RE: 1010 Wertland Street – Entrance Variance Revision

This letter is to request a revision to our prior request for an entrance variance along the Wertland Street elevation of the subject property.

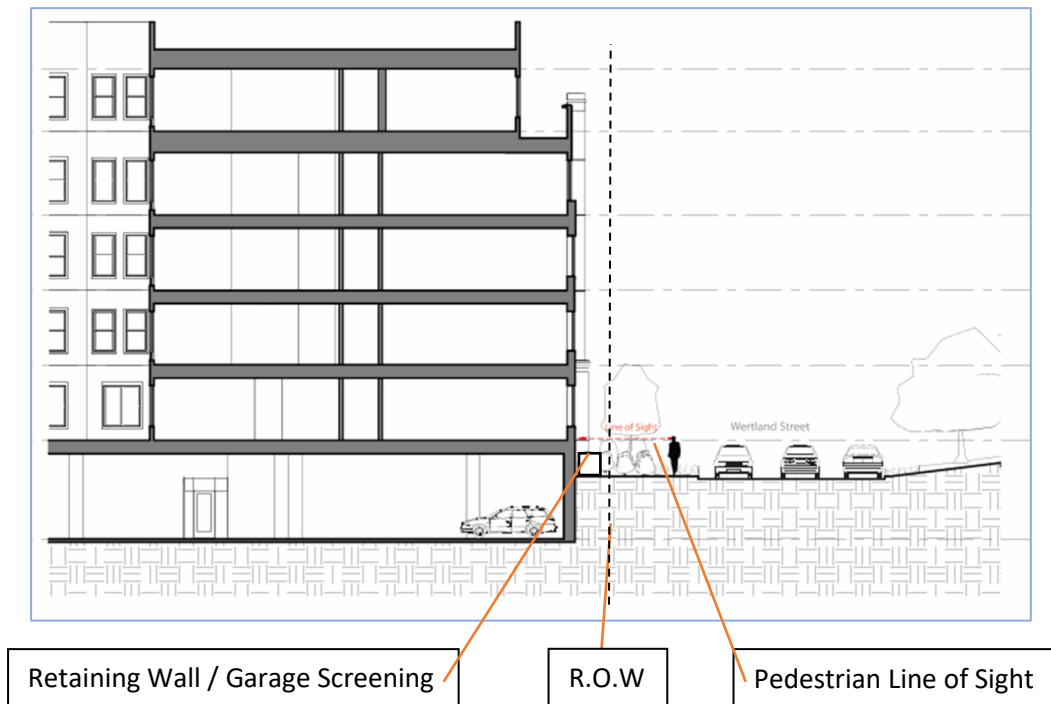
We are requesting a variance to provide only four entry points along the Wertland Street Elevation (shown in yellow in the elevation below). Using the 60' maximum spacing required by ordinance would place a door at the center point of the façade (shown in blue in the elevation below). We request to delete this central door location. With this deletion, the maximum distance requested between entry points in 124'-1".

The topography of the site makes it challenging to add the required "blue" entrance. The ground floor designation jumps from the first retail/garage level to the second residential level, based on ordinance section 34-2.10.1.F.2 (and as shown in the diagonal hatched areas in the image above) due to this changing topography.

If an additional entrance was included at the center of the Wertland Street elevation, it would require a significant number of stairs to traverse up to the second-floor residential area or down to the garage below and would need to penetrate through the retaining wall and landscaping being provided for the purpose of garage screening to meet other portions of ordinance as shown in the street / building section above. Entry to the second floor would also cause the unusual circumstance of having a single unit with direct street access in a building of 180 apartments.

In lieu of compliance with the required number of entrances on Wertland Street, blank wall treatments are proposed to enliven the public experience. See the images below for examples of foundation plantings and medium trees to be used for these treatments. Foundation planting species include: *Itea Virginiana* 'Henry's Garnet', *Hydrangea Quercus*, *Hydrangea Arbor*, and *Carex Mix*. Medium Tree species include: *Carpinus Caroliniana* 'Firespire', and *Nyssa Sylvatica* 'Fire Starter'.
